Metropolitan Historic Zoning Commission
Sunnyside in Sevier Park
3000 Granny White Pike
Nashville, Tennessee 37204
Telephone: (615) 862-7970
Fax: (615) 862-7974

STAFF RECOMMENDATION 2509 West Linden Avenue September 18, 2019

Application: New Construction—Addition
District: Hillsboro-West End Neighborhood Conservation Zoning Overlay
Council District: 18
Map and Parcel Number: 10415031100
Applicant: Leslie Ammons, Allard-Ward Architects
Project Lead: Sean Alexander, sean.alexander@nashville.gov

Drawings:
 Exterior Elevations
 Date:
 08.30.19

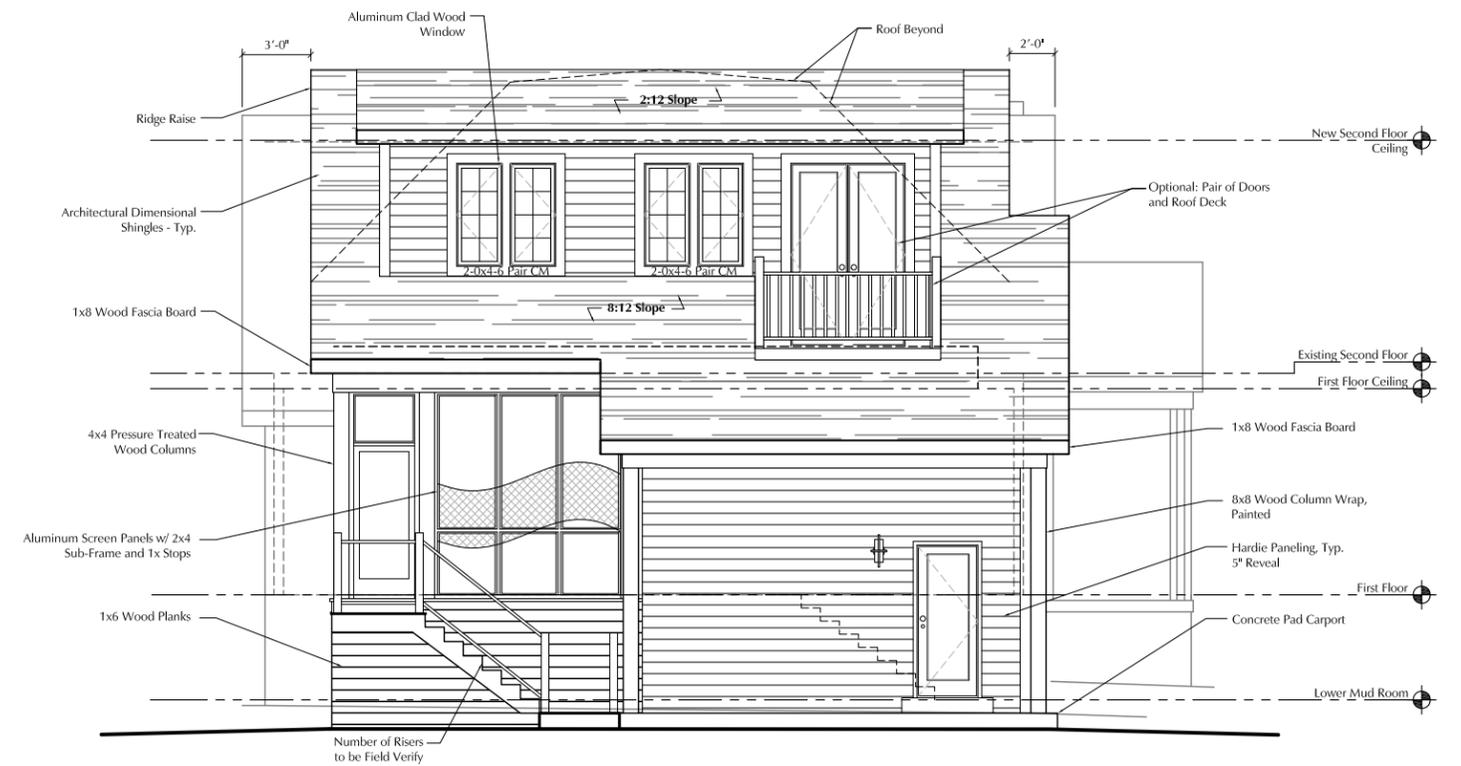
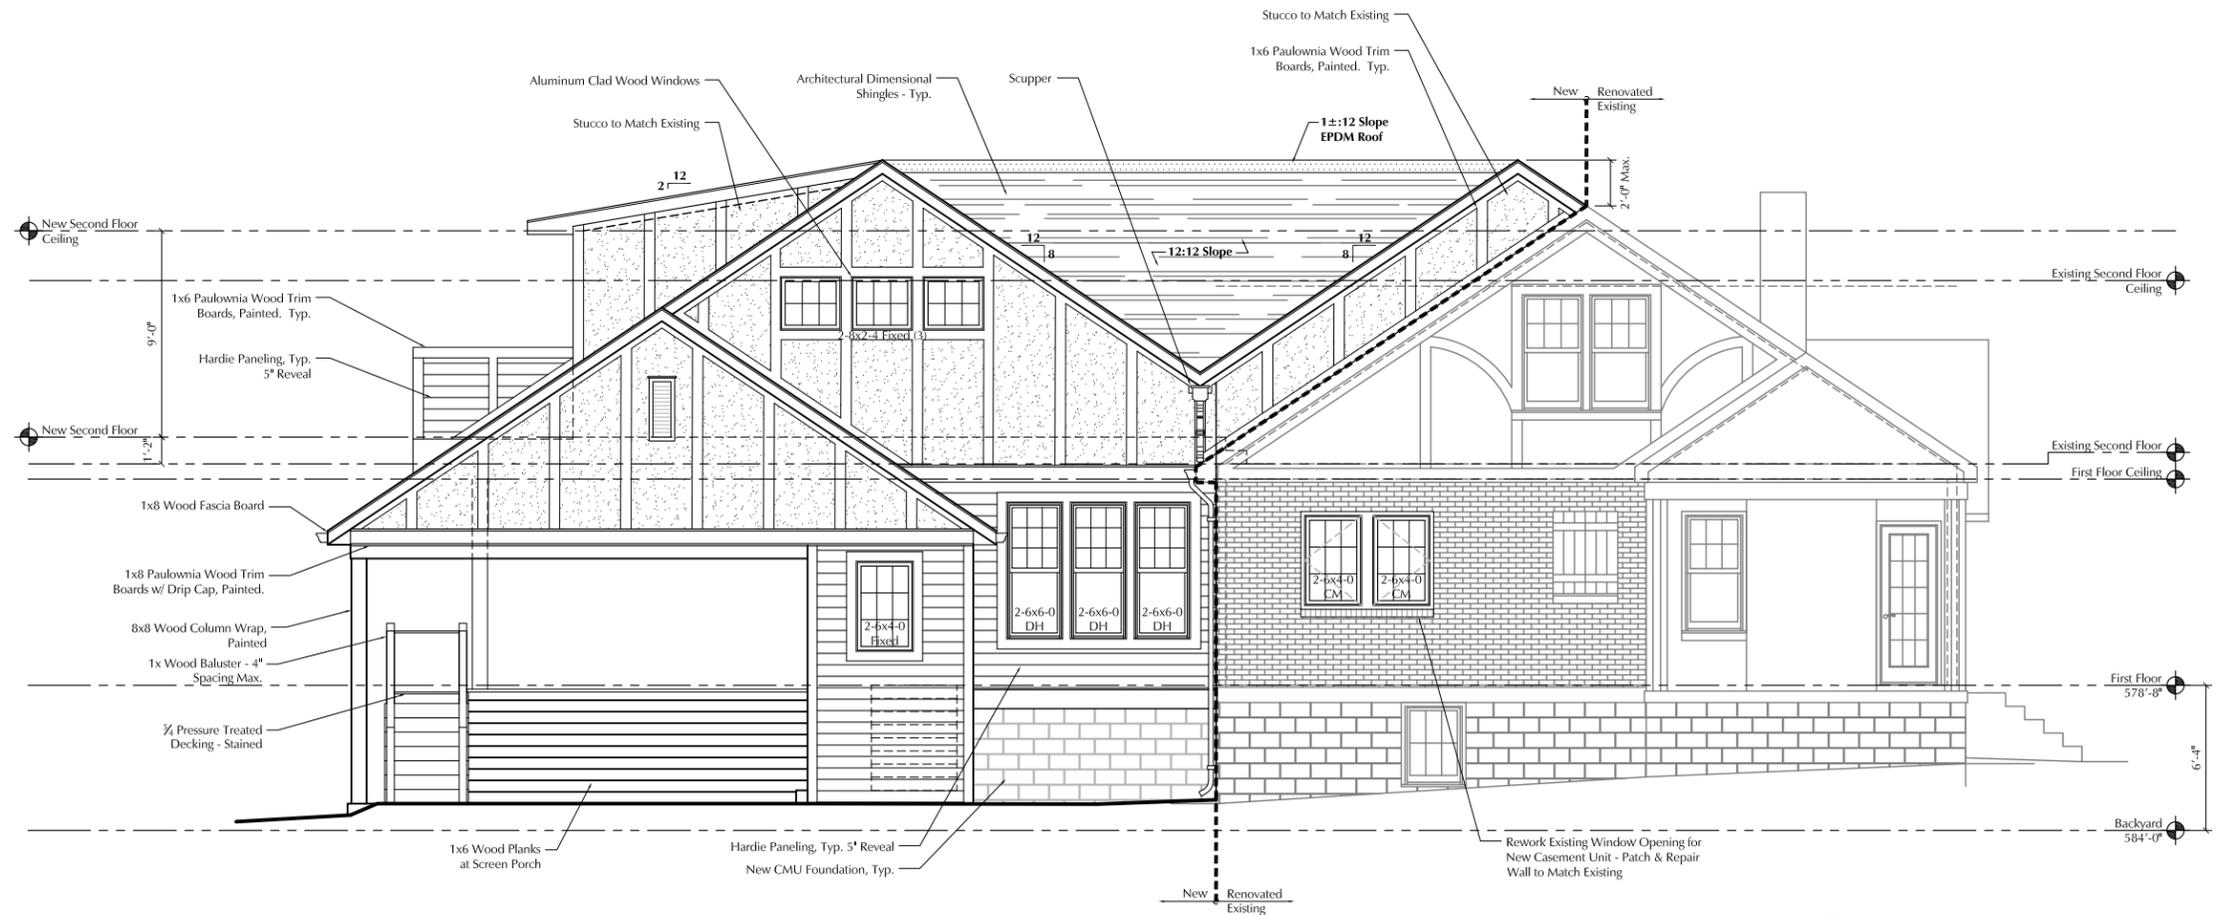
Design: The design of the addition is minimal in its detailing, in keeping with the Craftsman and Tudor Revival character of the historic house. The cladding of the addition will be siding on the first story with stucco and half-timbering on the upperstory, which will be compatible with the materials on the original structure.

Proportion and Rhythm of Openings: The windows on the first story of the proposed addition will be vertically oriented windows with divided lights, which is consistent with the windows on the historic house. There will be smaller square windows on the upperstory of the addition. Windows are typically vertically oriented on full stories, but it is not uncommon for upperstory gable fields to have smaller windows, or no windows at all.

Staff finds the project’s proportion and rhythm of openings will meet section II.B.1.g of the design guidelines.
